NOTICE OF PUBLIC HEARING FOREST GROVE HISTORIC LANDMARKS BOARD FILE NUMBER 311-24-000027-PLNG

Historic Landmark Review Staff Report and Recommendation

Report Date:	June 20, 2024
Hearing Date:	June 25, 2024
Request:	Historic Landmarks Board approval to expand a dormer on partially visible exterior side of a designated historic home.
File Number:	311-24-000027-PLNG
Property Location:	2620 18 th Avenue
Legal Description:	Washington County Map and Tax Lot 1S3065AC00300
Applicants:	Maxine DiPasquale & Michael Berger
Comprehensive Plan and Zoning Map Designations:	High Density Residential (HDR) Residential Multi-Unit High Density (RMH)
Historic District	Clark National Register Historic District
Applicable Standards and Criteria:	City of Forest Grove Development Code: <i>§17.5.220 Procedure for Review of Proposed Work Affecting the Exterior of Landmarks</i> City of Forest Grove Design Guidelines Handbook: <i>Focus Area V – Historic District Design Guidelines</i>
Reviewing Staff:	Daniel Riordan, Senior Planner
Recommendation:	Based on the evidence in the record, and findings contained in the staff report, staff recommends, that the Historic Landmarks Board approve the proposed dormer exp

Side of House with Existing Dormer

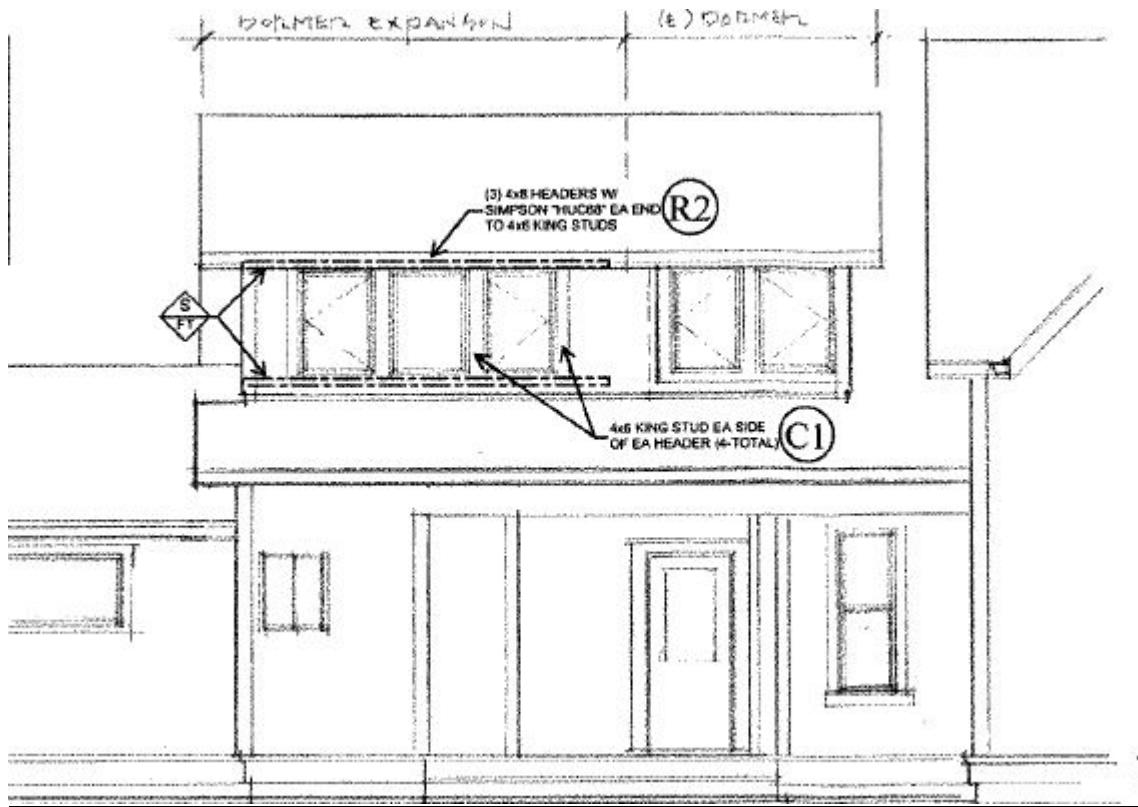
A large western red cedar tree obscures the view of the northeast corner of the house from 18th Avenue. However, from a distance the existing dormer is visible from the public right-of-way when approaching the home from the east.

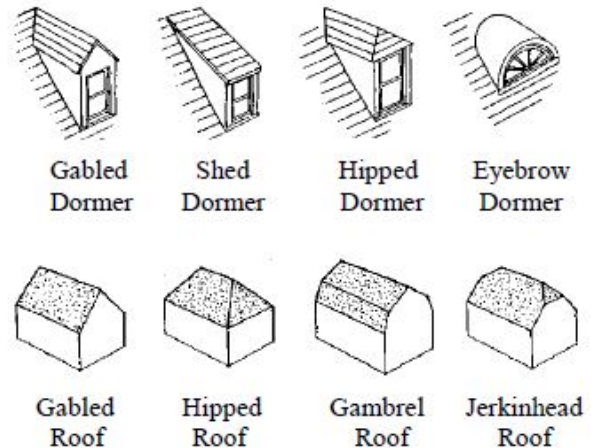
Finding: *The existing dormer appears to be shed style. Therefore, the total area for the dormer is limited to 50% of the roof's slope. Based on the plans provided by the applicant, it appears the*

proposed dormer expansion would exceed the 50% limitation. Therefore, the Historic Landmarks Board must either approve a deviation from the standard or require that the dormer expansion adhere to the 50% limitation.

EAST ELEVATION 1/4" = 1'-0"

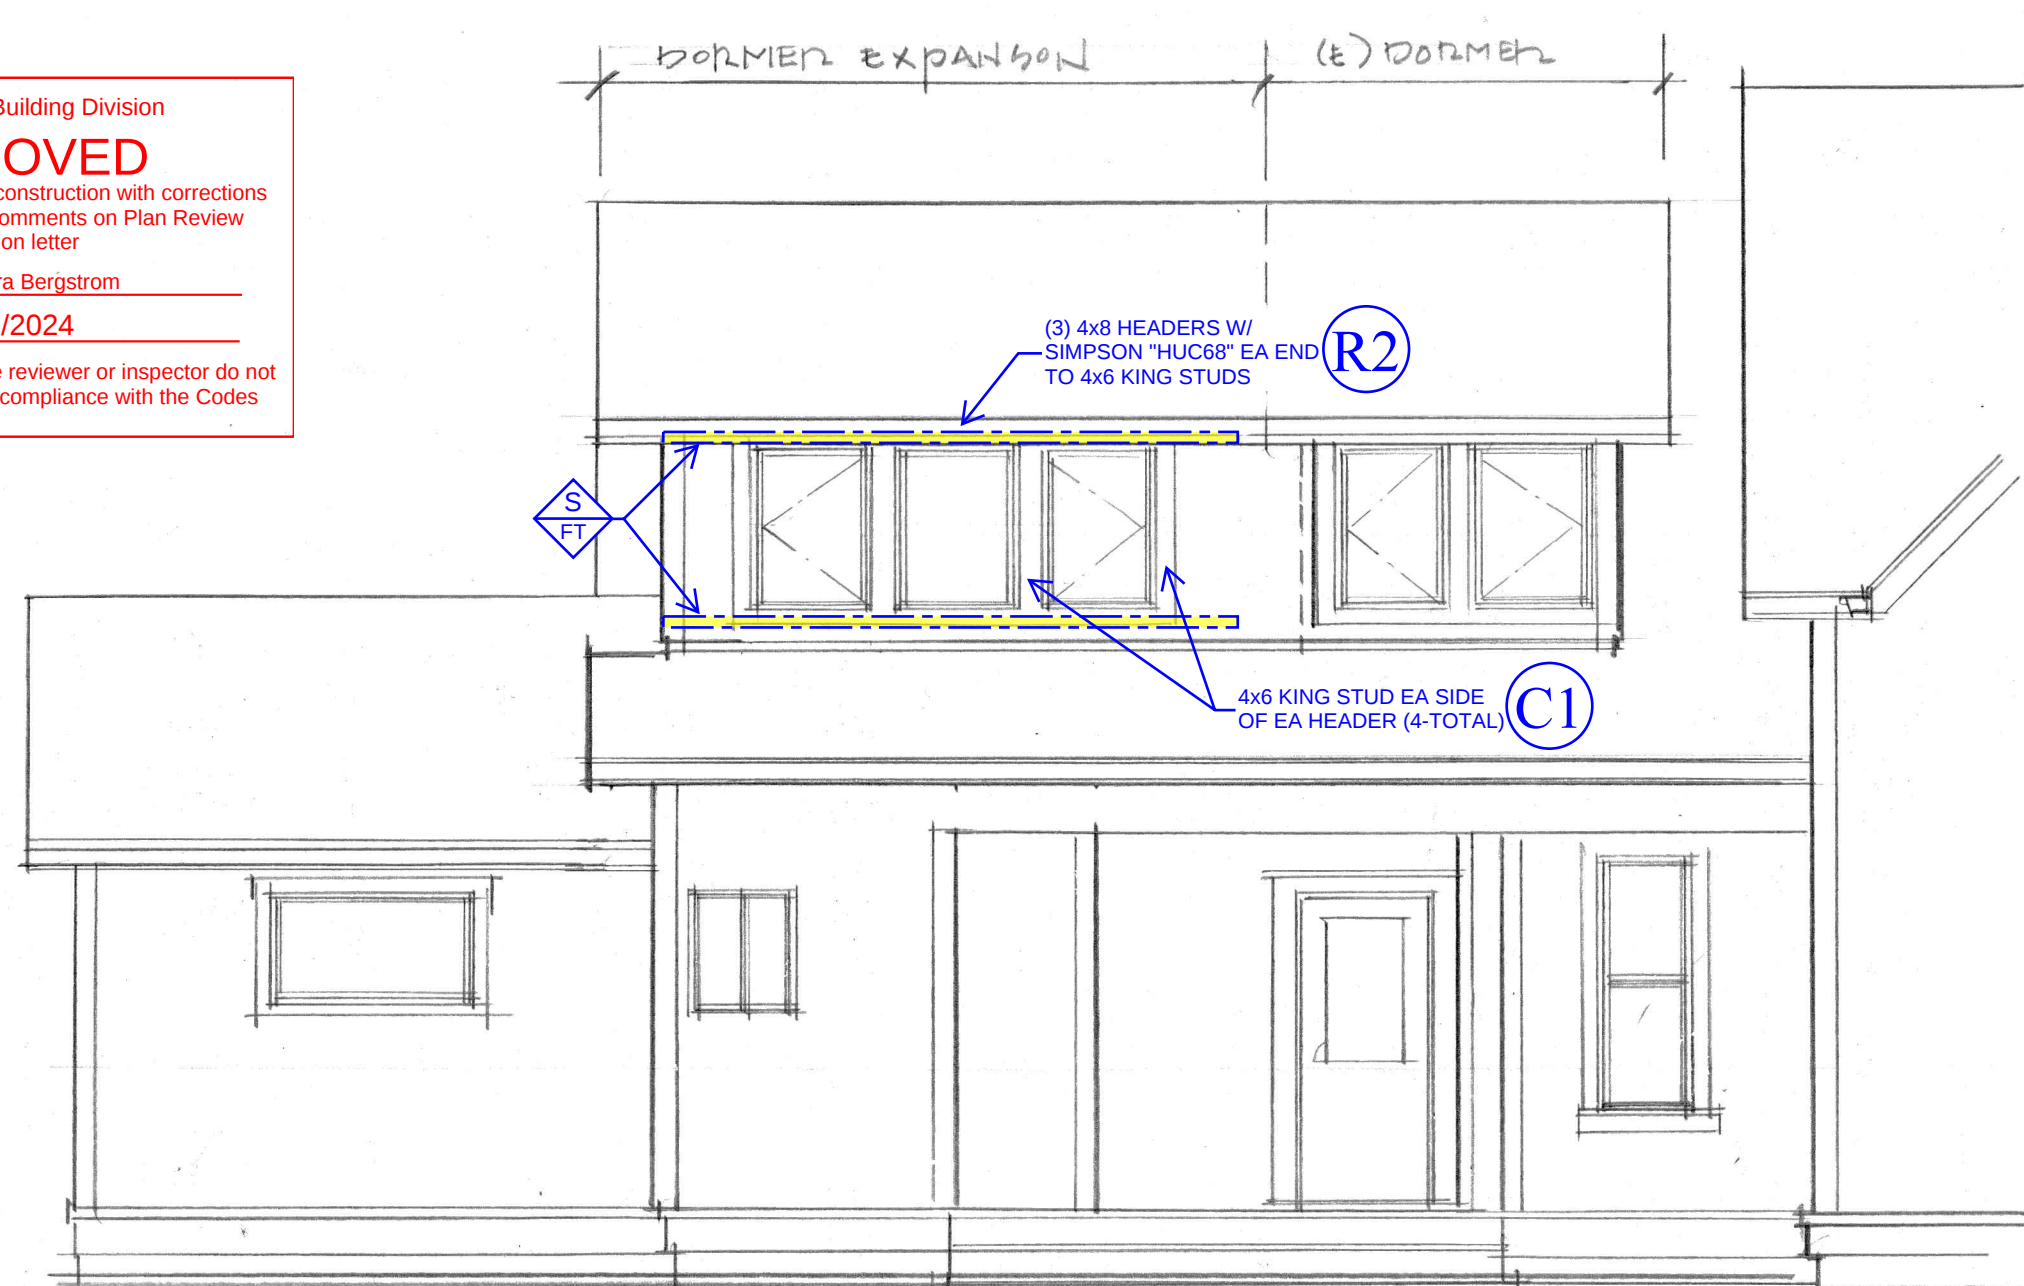
Finding: The proposed dormer expansion does not affect the front building elevation and is toward the rear of the house. There is a large tree that obscures a portion of the building elevation affected by the dormer expansion. The tree minimizes the view from the public right-of-way. This design guideline is met.

Finding: The existing dormer has two window openings. The two window openings will be retained, and three new openings will be added. Since new upper-level window openings on visible sides of historic buildings are not allowed, the applicable standard above is not met.

If the HLB concludes that the proposal meets the intent of the applicable design guidelines, staff recommends that approval of the application include the following conditions:

1. The applicant is bound by the conditions of approval adopted by the Historic Landmarks Board.
 2. New material should match the material of the home in composition, design, and other visual qualities.
 3. Modifications to the approved project design shall be reviewed by the Historic Landmarks Board through the Type III procedure required for the original approval.
 4. Window material and design shall be compatible with the existing dormer windows and comply with the applicable standards for the historic district. New window materials not allowed on visible sides of historic landmarks include
 5. The applicant shall comply with all applicable City building codes and standards.
3. Deny the request, stating specific reasons why the proposal does not meet the intent of the applicable design guidelines based on the evidence included in the record.
